Subject: Duke Energy Corporation  
Oconee Nuclear Station - Units 1, 2, and 3  
Docket Nos. 50-269, 50-270, and 50-287

Revisions to Topical Report DPC-NE-3003 In Support of  
Steam Generator Replacement  
Response to NRC Staff Request for Additional  
Information

Enclosed herein, please find the Duke Energy Corporation (Duke) response to the May 12, 2003 NRC staff's request for additional information concerning topical report DPC-NE-3003, Revision 1, "Mass and Energy Release and Containment Response Methodology."

### **Duke Power Response To Request For Additional Information**

## GOTHIC 7.0 - FATHOMS COMPARISON

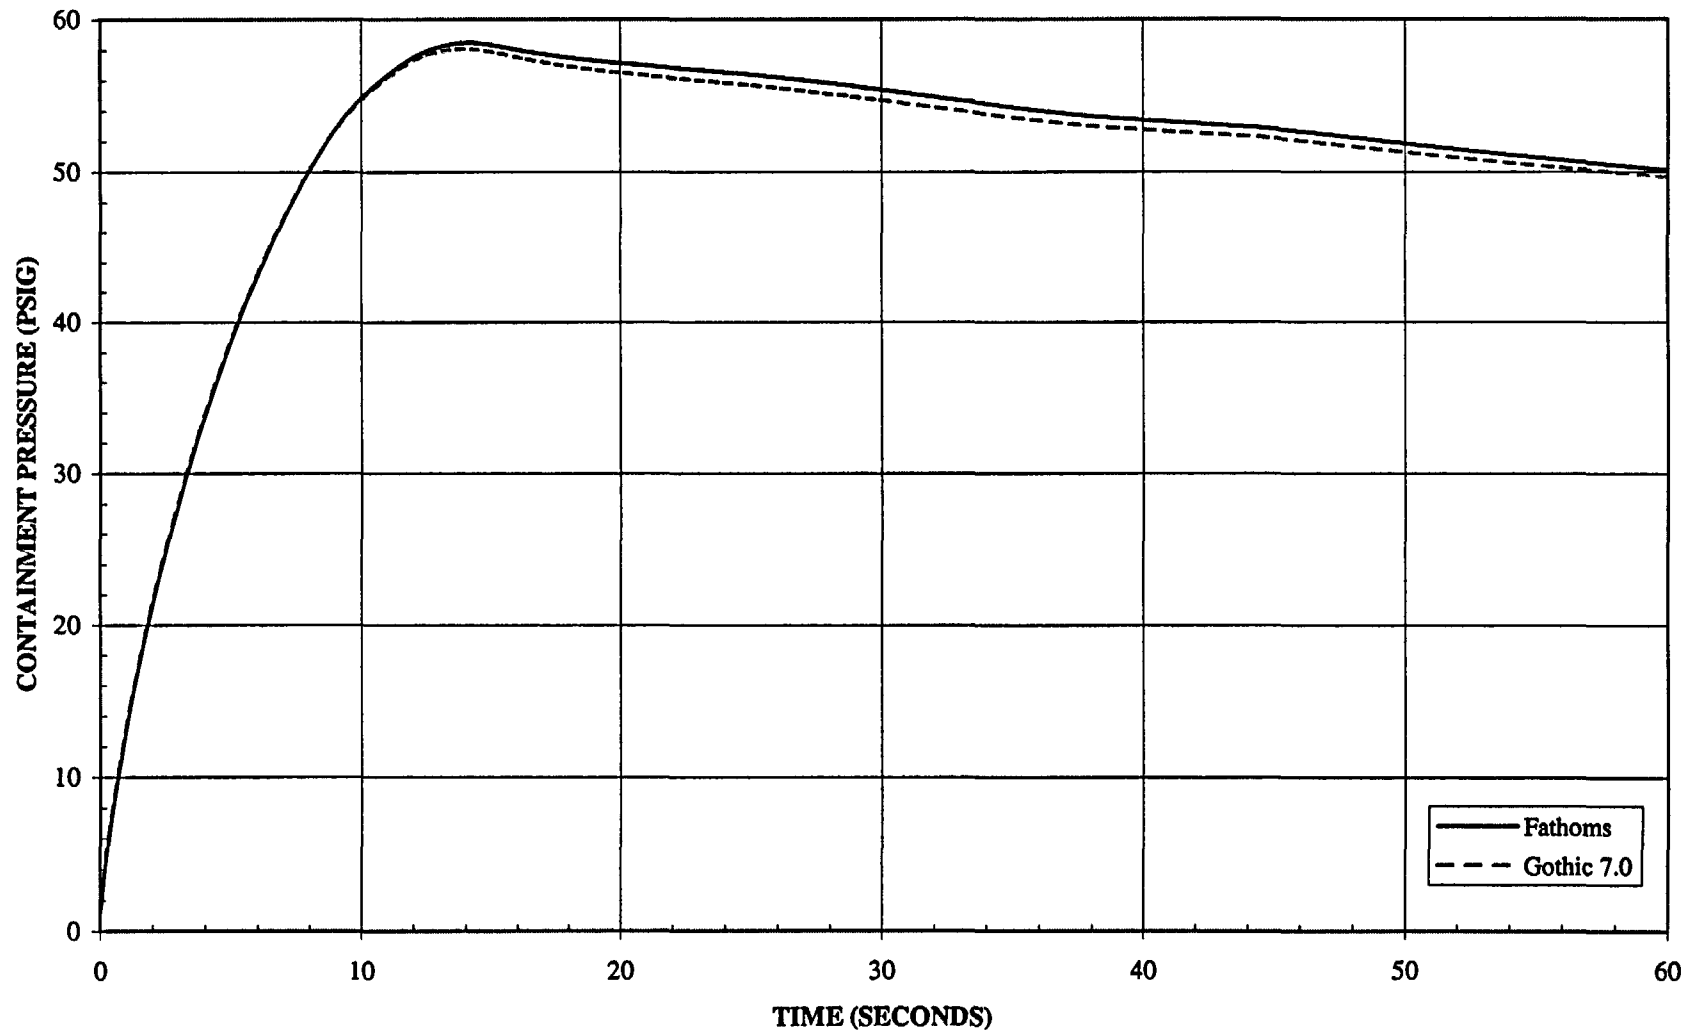
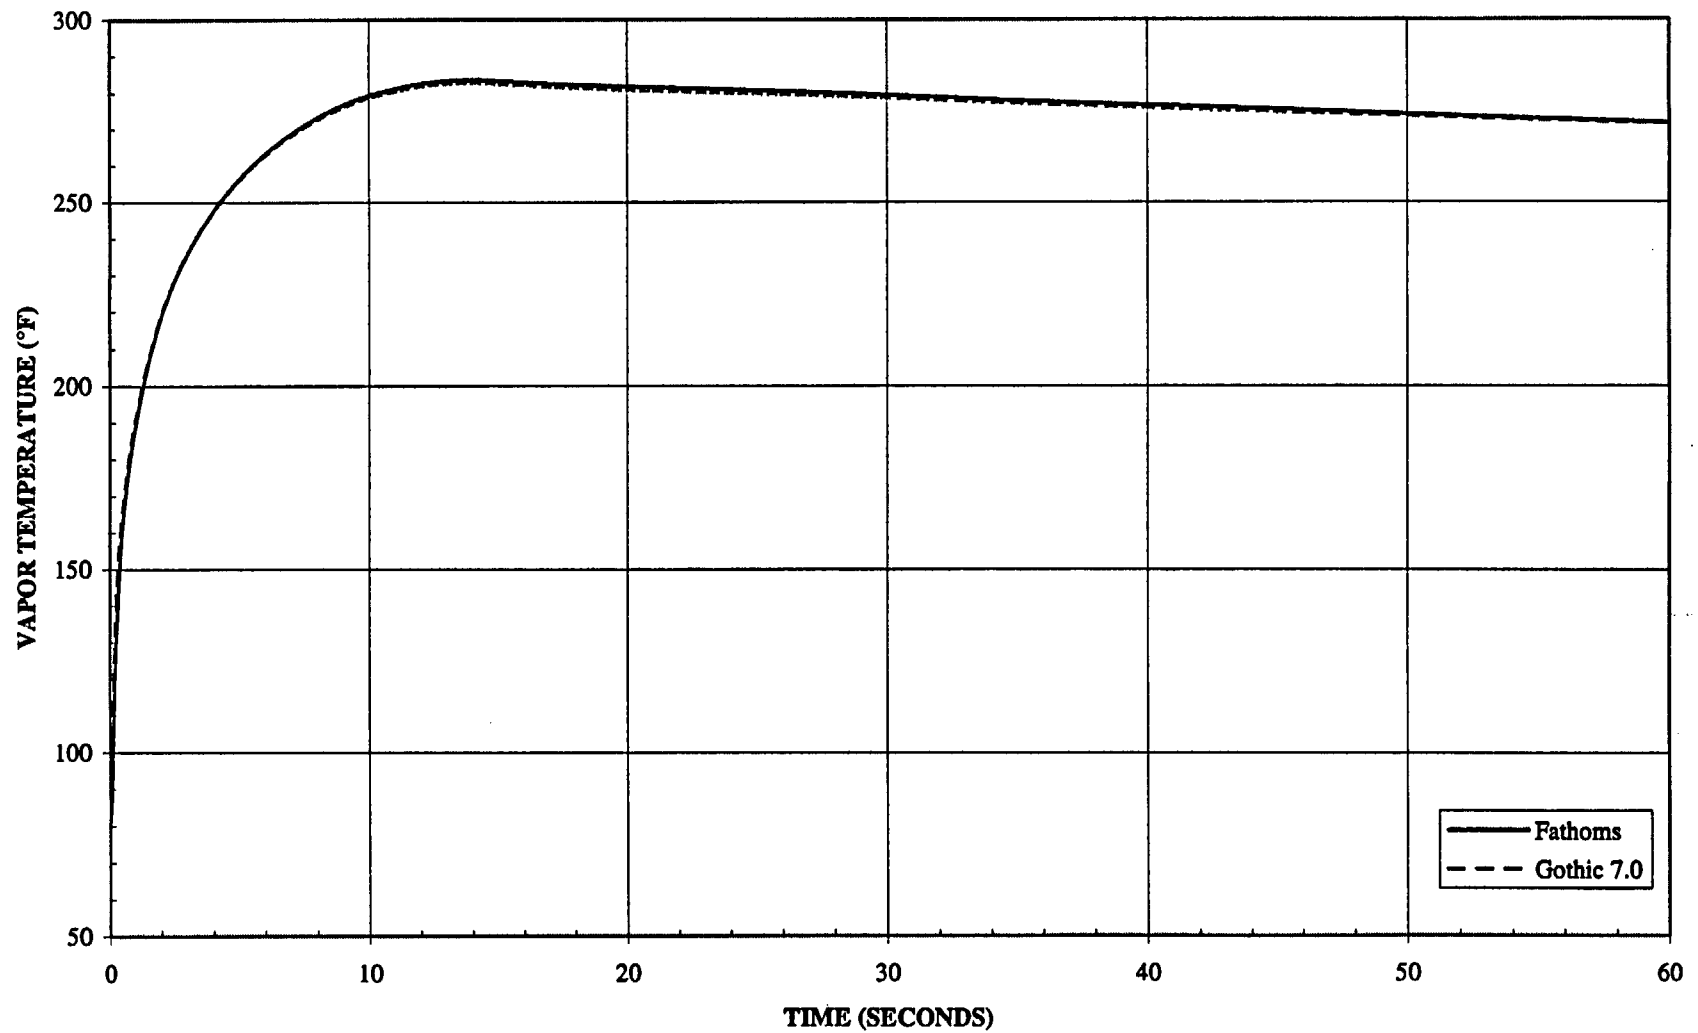
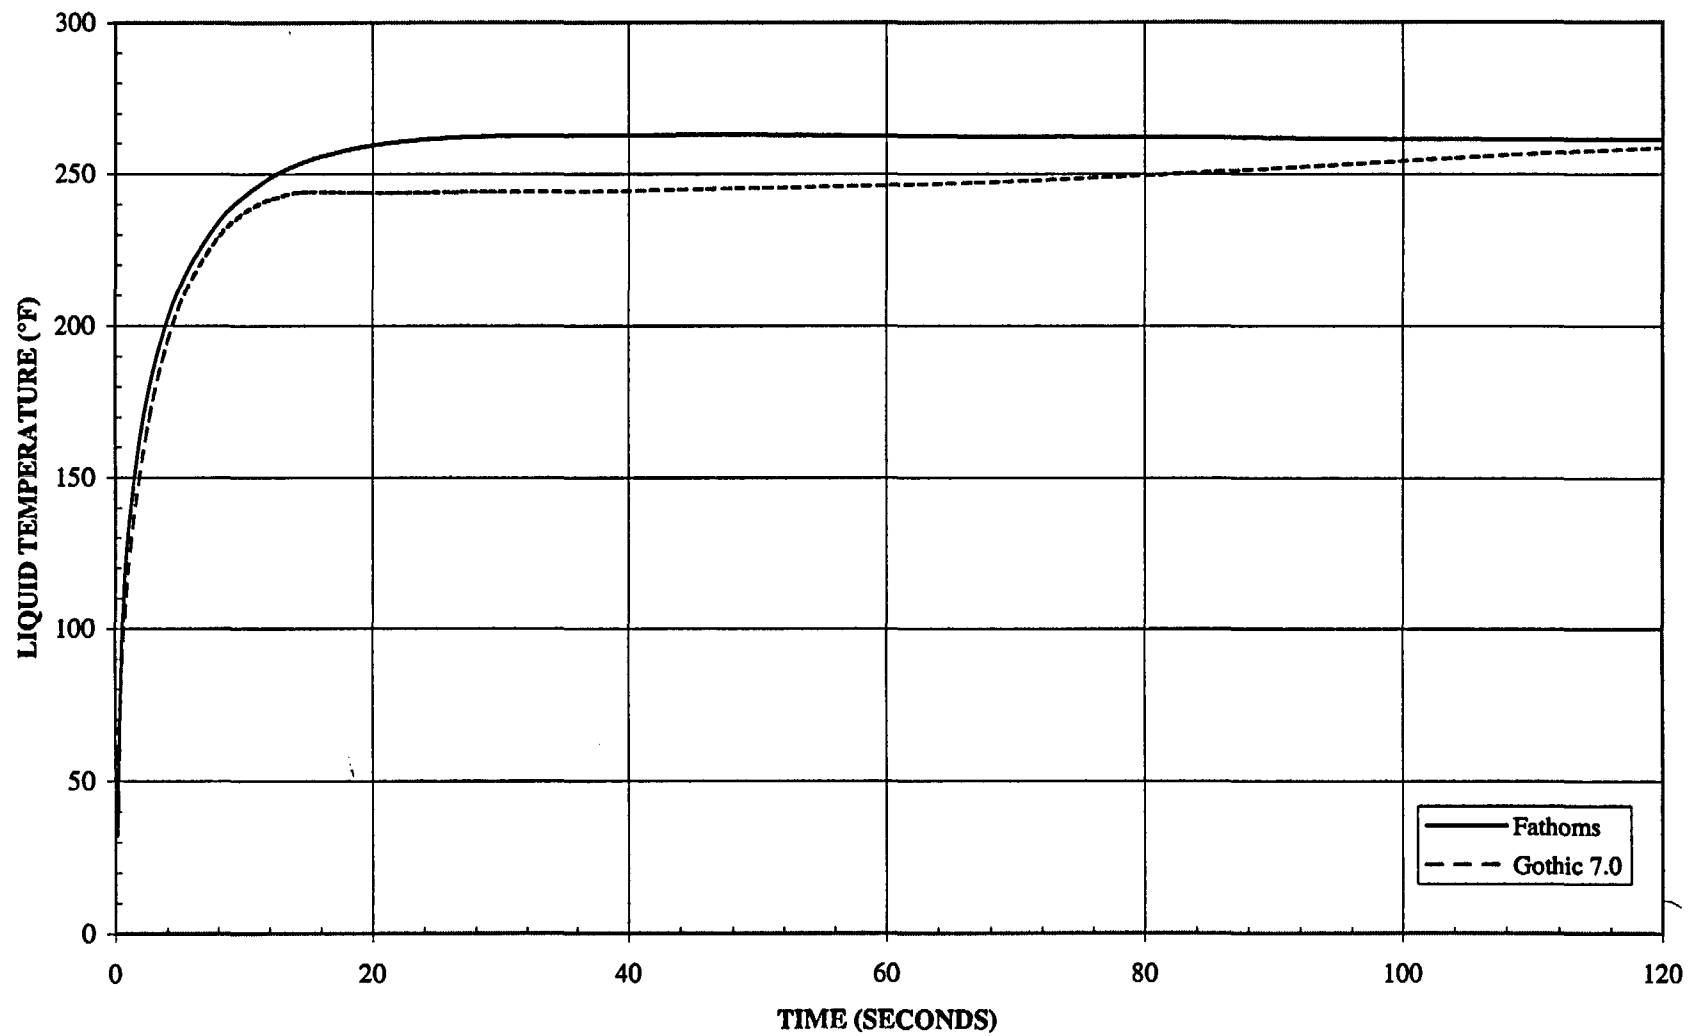
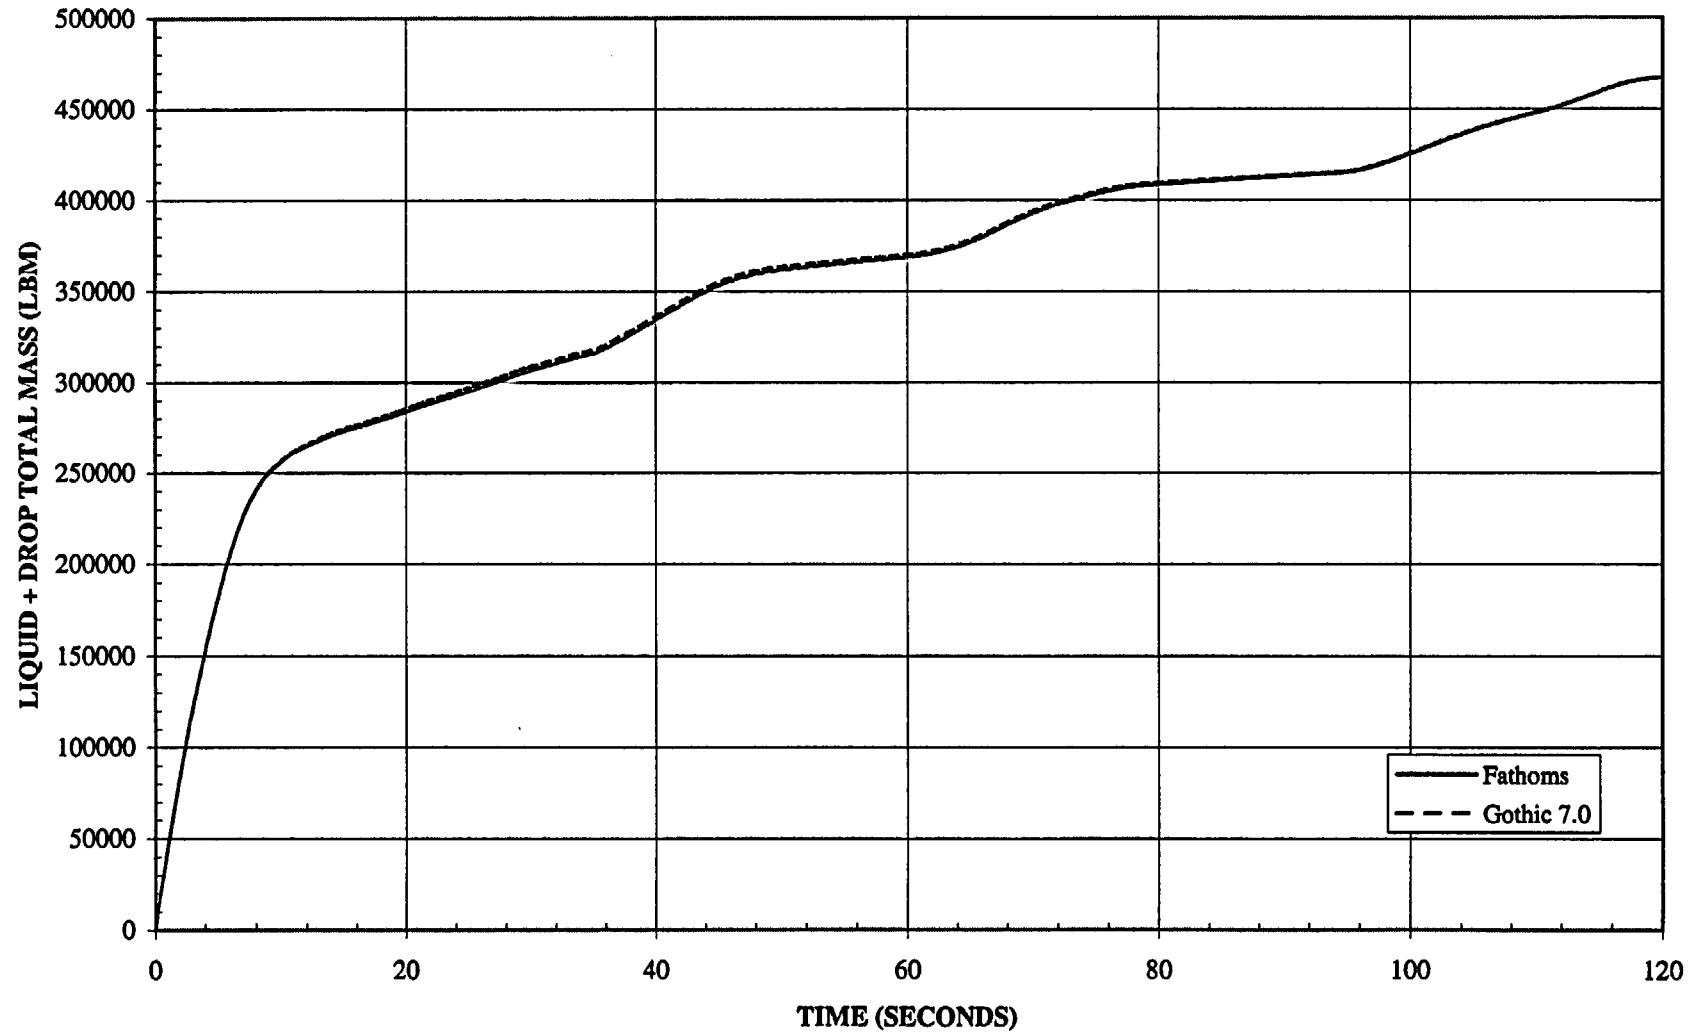
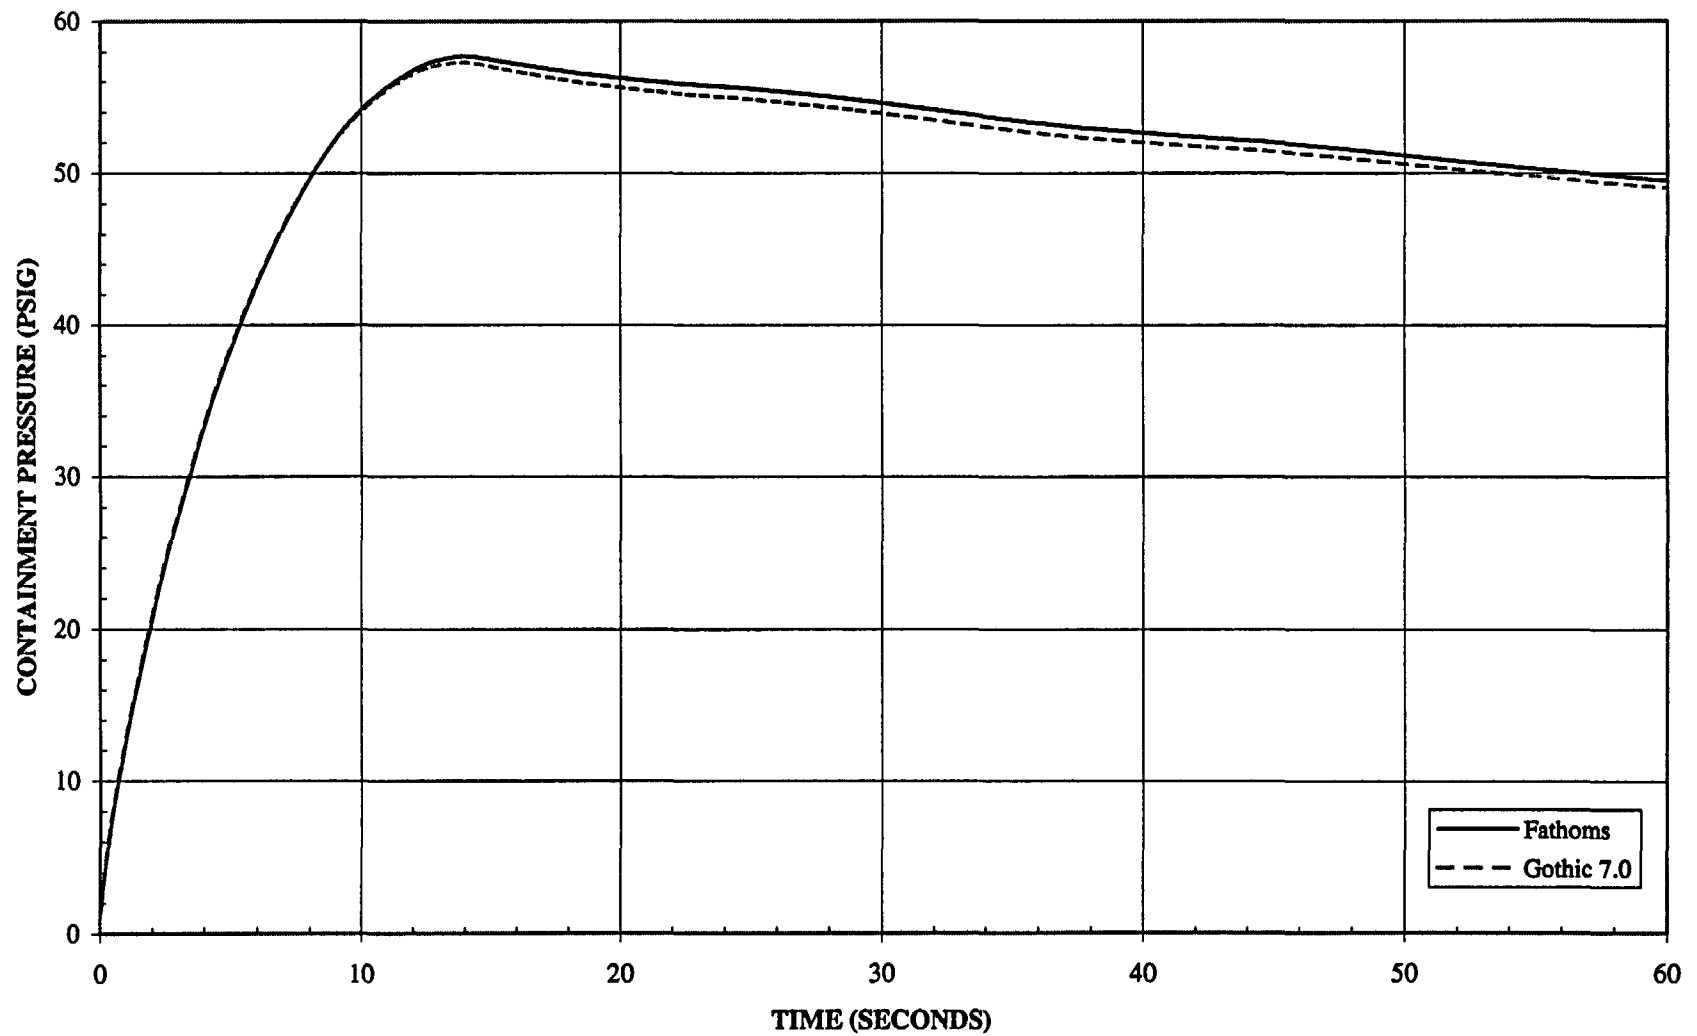
3. Please provide the results using the GOTHIC 7.0 code of peak pressure and temperature calculations for the sensitivity cases listed in Table 3.1-1 of DPC-NE-3003 in tabular and graphical form. If the results or conclusions are significantly different from those presented in DPC-NE-3003P, explain the difference.

Response: Table 3.1-1 of DPC-NE-3003 describes a spectrum of LOCA peak pressure cases including a range of break locations and sensitivity analyses for several important modeling assumptions. The staff's request is understood to focus on the difference in the predicted results from the FATHOMS and GOTHIC 7.0 code versions. Rather than show the comparison for the cases in Table 3.1-1, a different set of cases has been selected which is more focused on the current knowledge of the key sensitivity parameters. Also, the results presented are for the ROTSGs, which is the subject of Revision 1 to the topical report.

The results of the 14 code comparison analyses are shown in Table 3-1 below and in the figures that follow. In general, the pressure and vapor temperature response predictions were very similar in both magnitude and trend. GOTHIC 7.0 predictions for peak pressures and vapor temperature were slightly lower (~0.5 psig and 0.5°F). These differences are consistent with the code model differences described in the response to Question #1. Both codes predict a saturated containment atmosphere due to the large amount of drops injected. The slightly lower pressure, vapor temperature, and liquid temperature from GOTHIC 7.0 may be attributed to additional drop hold up in the atmosphere. This effectively increases the heat capacity of the atmosphere and reduces the temperature rise for a given energy addition. A comparison of the total liquid and drop masses, and liquid temperatures, show the predictions of the two codes to be essentially the same. This is consistent with the changes in the drop deposition and entrainment models discussed in Question #1. These results show that the two code versions give essentially similar results for the same break location and initial and boundary conditions.
